May 8, 2026**Addendum No. 01****File Reference Number: RFP 2026 018****Title: Englehart Lumber Transload Facility****RE: Clarifications/Questions**

Please refer to the following information / clarifications:

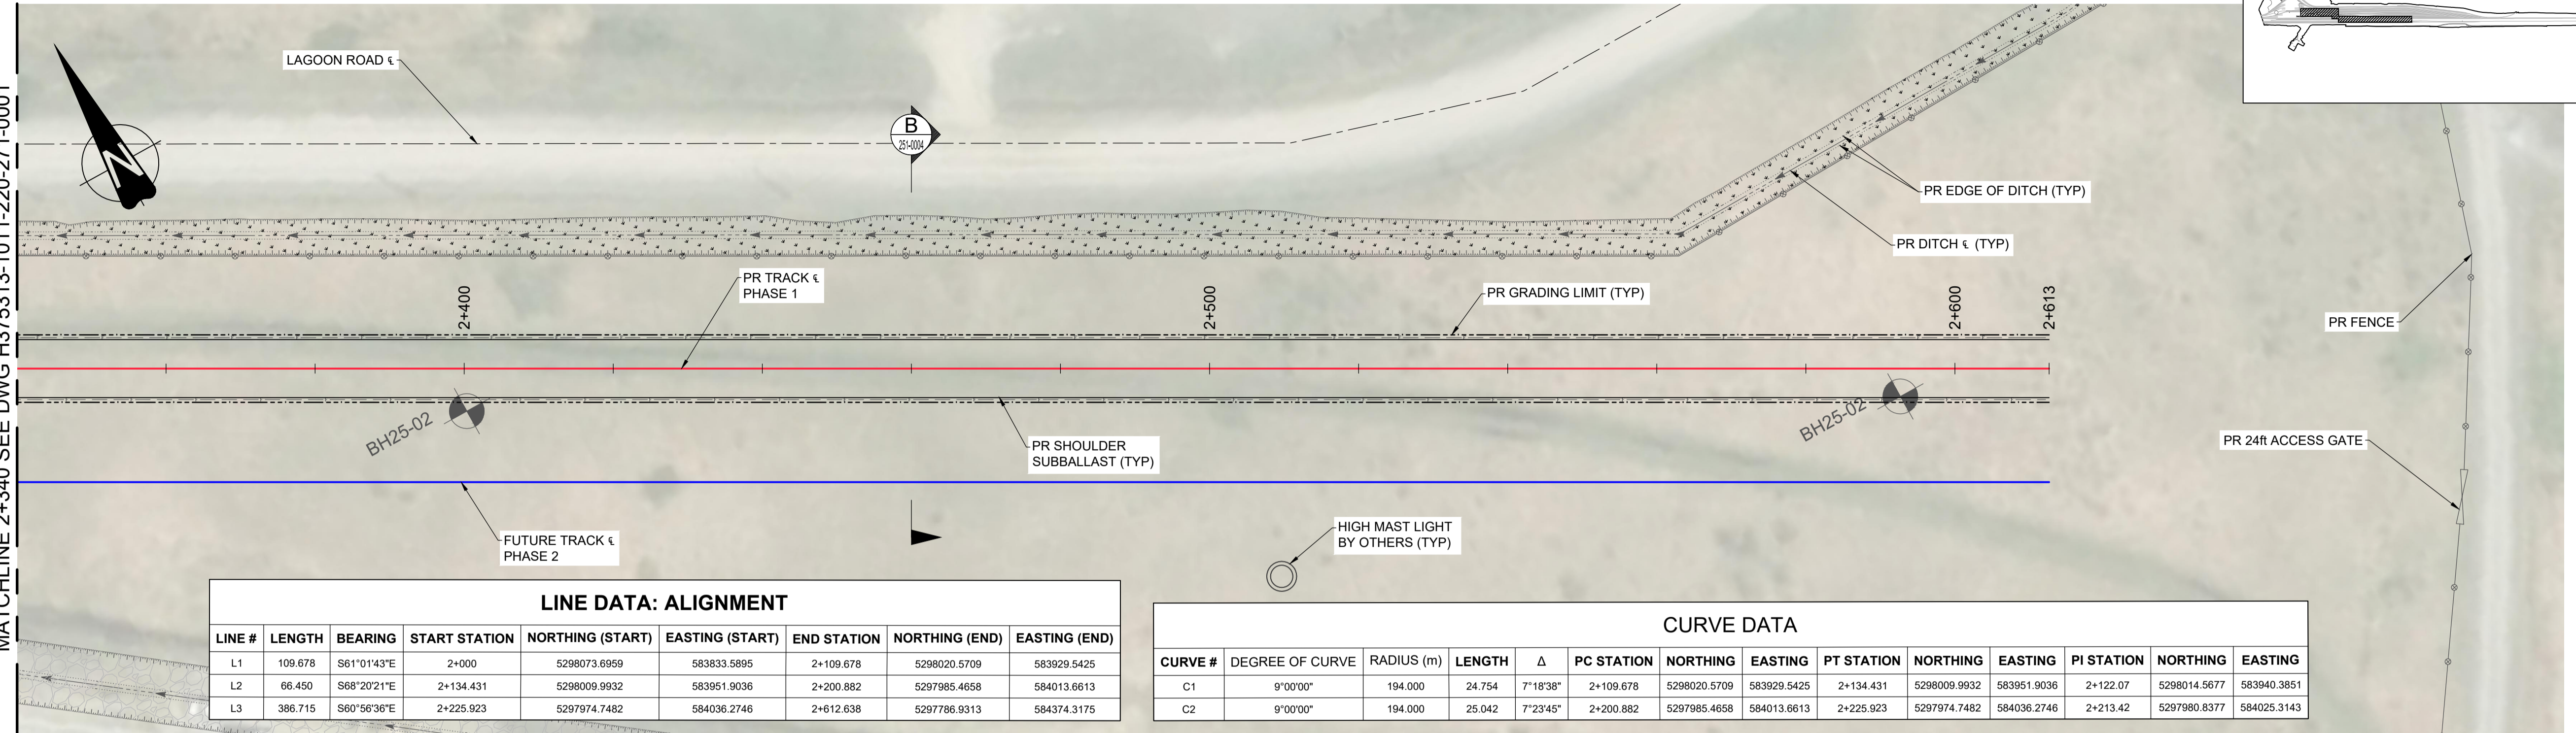
Item 4: With reference to the Englehart Lumber Yard pricing form, could you please confirm the disposal requirements for the following items:

- B2 – Common Excavation (Non-contaminated)
- B3 – Common Excavation (Contaminated)
- E2 – Removal of Existing Granular Material from Sub-Excavation Areas

Specifically, please clarify whether these materials are to be:

1. Disposed of on-site within the project limits, or
2. Hauled and disposed of off-site at an approved facility

If off-site disposal is required, please confirm:

- Any designated disposal locations (if applicable)
- Responsibility for disposal fees and tipping costs
- Haul distance assumptions (if to be included in pricing)

- B2 – Common Excavation (Non-contaminated) soil shall be stockpiled onsite, in strict consultation with ONTC, at general location as identified below (marked in yellow). Should there be any deviation from this approach, ONTC will further communicate any specific needs.

- B3 - Common Excavation (Contaminated) soil shall be accounted for, controlled/collected, hauled and disposed of off-site by the Contractor at an approved facility. It will be the Contractor’s responsibility to abide by all applicable laws, regulations and background engineering design/reporting in this respect, accordingly.
- E2 - Removal of Existing Granular Material from Sub-Excavation Areas – if non-contaminated material, should be managed the same as B2. If contaminated material, should be managed the same as B3.

Note: Suitable offsite disposal locations, logistics and all associated considerations/costs shall be the responsibility of the Contractor, and shall be clearly investigated, outlined and accounted for in Proponents’ submissions and final costing.

ONTC ENGLEHART YARD
LUMBER YARD
TRACK PLAN & PROFILE
STA. 2+340 TO STA. 2+613

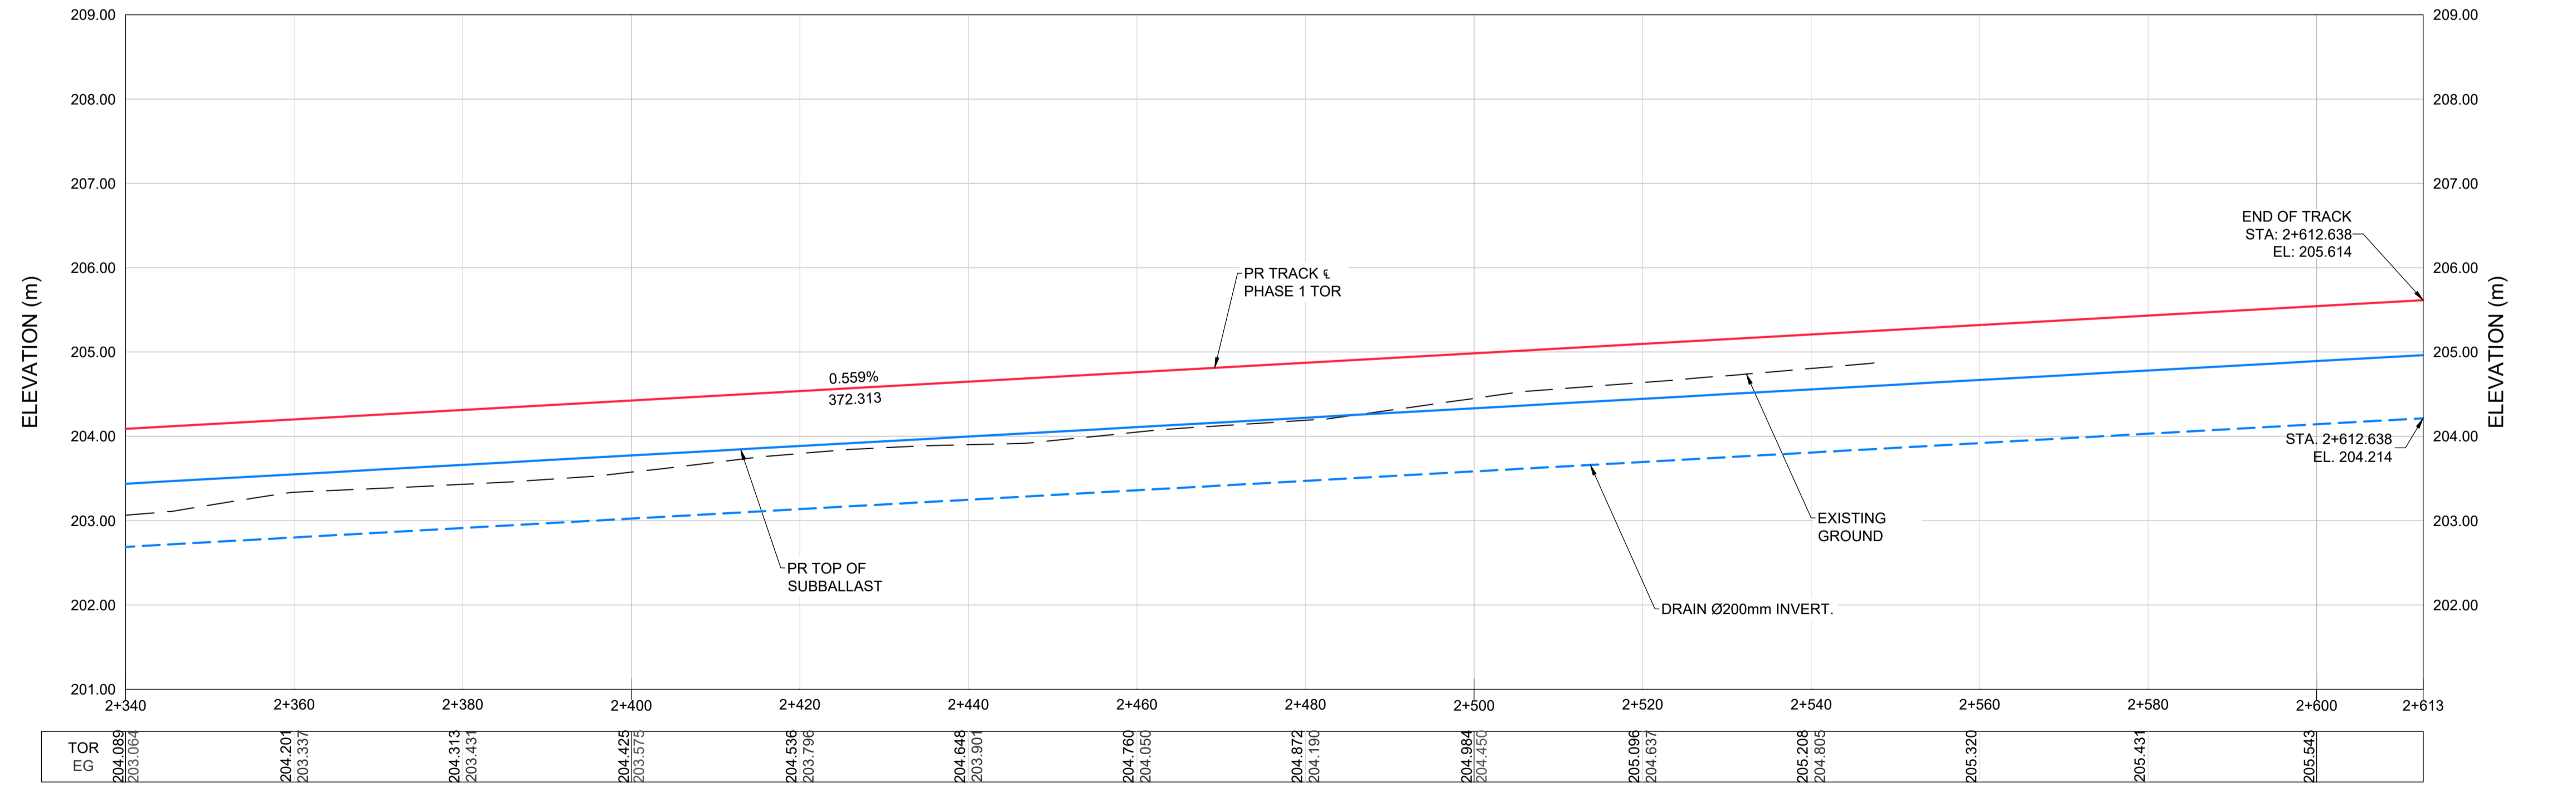
Item 3: The track drawings supplied with the package only show station 2+000 to 2+340 (drawing H375313-1011-220-271-0001). Is there another track drawing to end of siding?

Answer: Please see the attached Drawings at Appendix A, which form part of this Addendum No. 01.

DRAWING NO.	DRAWING NAME
H375313-1011-220-271-0005	LUMBER YARD TRACK PLAN & PROFILE STA. 2+340 TO STA. 2+613
H375313-1011-220-251-0009	LUMBER YARD DETAIL SHEET
H375313-1011-220-273-0001	LUMBER YARD GRADING CROSS SECTIONS
